REVISED

Request	-	Special Use Permit for a tobacco shop
Location	-	606 N. Reynolds Road
Applicant / Owner	-	Danny Abuhashish P.O. Box 902 Sylvania, OH 43560
Engineer	-	John A Weithman, PE P.O. Box 216 Genoa, OH 43430
Site Description		
Zoning Area Frontage Existing Use Proposed use		CR / Regional Commercial ± 0.118 acres ± 90' along Reynolds Road ± 57' along Nebraska Avenue Vacant commercial Tobacco shop and cellular phone store
Area Description		
North	-	Carwash, Prestler Street and commercial uses / CR
South	-	Nebraska Avenue and Keil farm / CR and RS6
East	-	Multi-family unit and single-family homes / CR and RS6
West	-	Reynolds Road, auto parts store and single-family homes / CR and RS6

SPECIAL USE PERMIT TOLEDO CITY PLAN COMMISSION REF: SUP24-00113 DATE: February 13, 2025 TIME: 2:00 P.M.

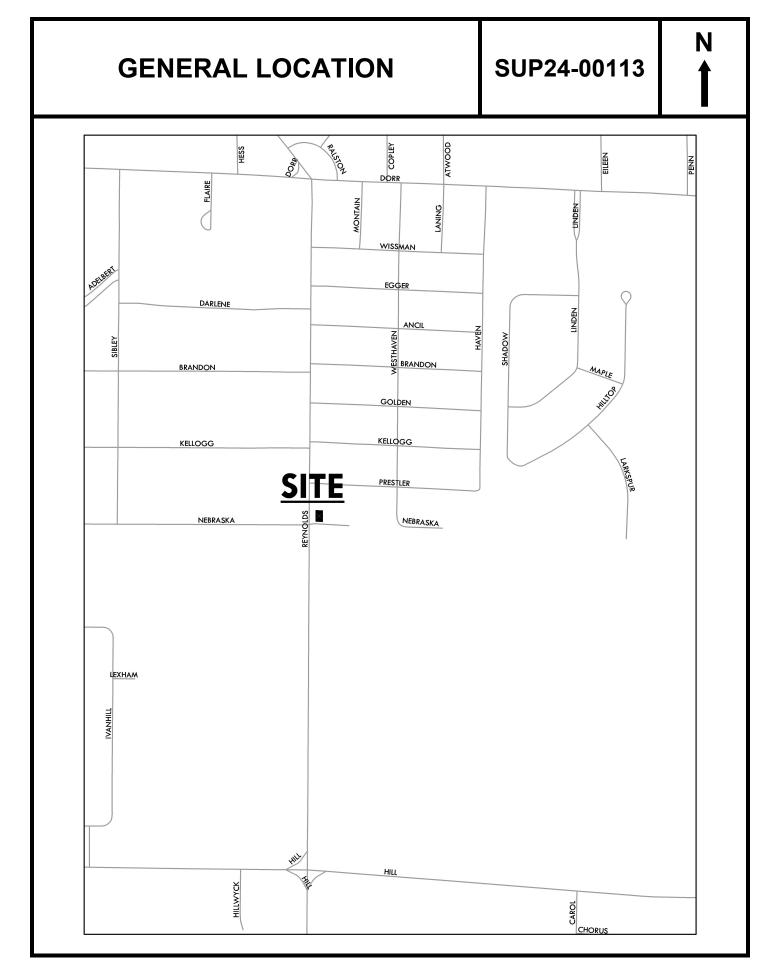
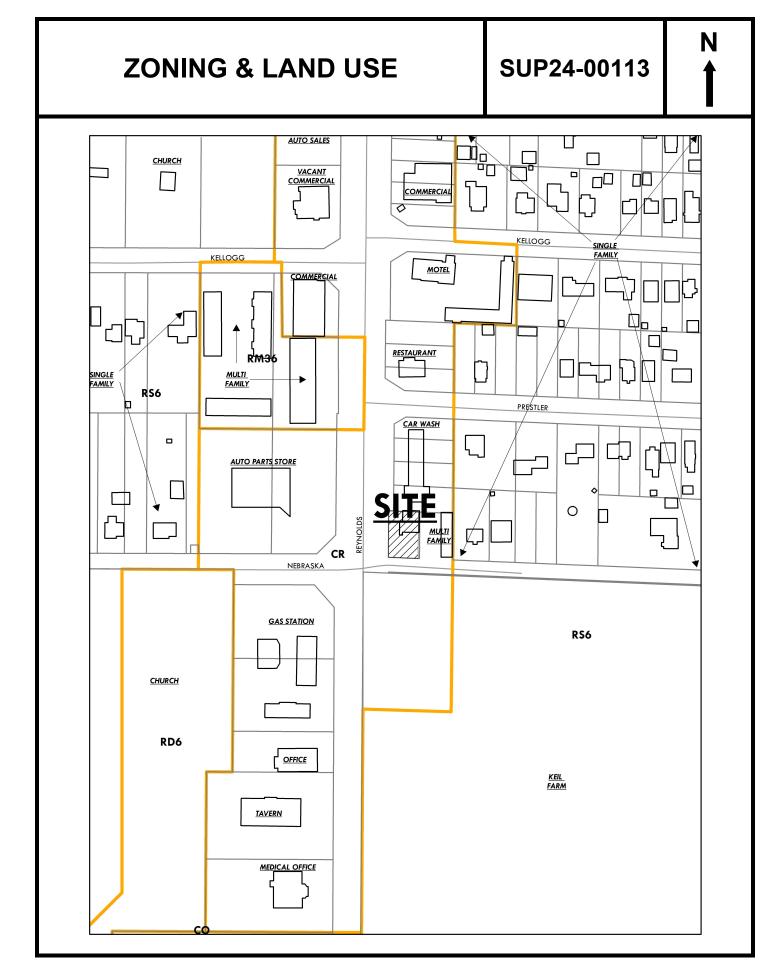
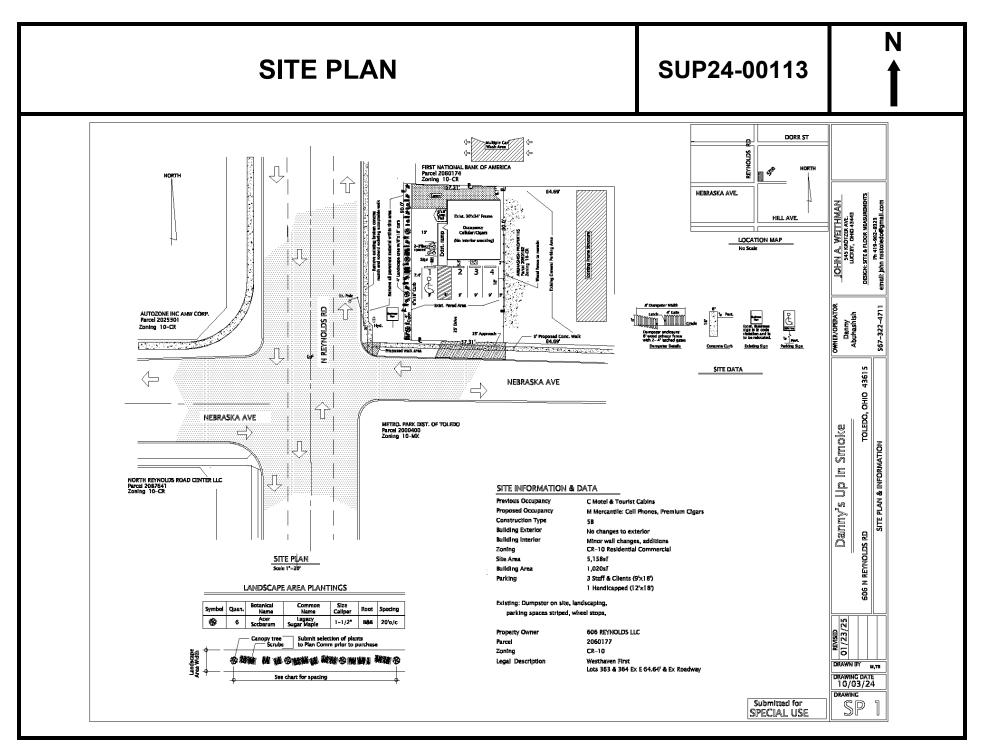
- 5. The existing pavement, if it slopes to the southeast, will continue to drain acceptably, although this is speculative because the site plan does not show existing pavement grading. If any existing sheet flow goes westward, the proposed curb needs to be done without creating a nuisance condition of retained drainage at the new curb. Anywhere drainage is redirected to landscaping at the west, north or south, needs attention to grading so as to not creating water sitting on the pavement, but instead flowing through and over any new landscaping, sidewalk, and drive approach work.

- 22. Per TMC107.1303, sidewalks shall be constructed along all public streets, at the time of development, of any parcel in any commercial district. A three-foot (3') wide sidewalk is proposed to be installed along Nebraska Avenue. Not acceptable as depicted. Per Condition #13, the sidewalk shall be a minimum of four-foot (4') wide.

- b. Per TMC§1108.0203(G), a dumpster may not be in any required setback or landscape buffers and shall be located as far away from residential areas as possible. The dumpster is depicted in the front yard along Reynolds Road. Not acceptable as depicted. A waiver will need to be approved or the dumpster relocated to an acceptable location.

- e. The location number, height, diameter and species of any materials to be planted and maintained, as well as the location and number of any existing trees to be retained. Not acceptable as depicted. Proposed shrub information shall be added to the plant schedule.
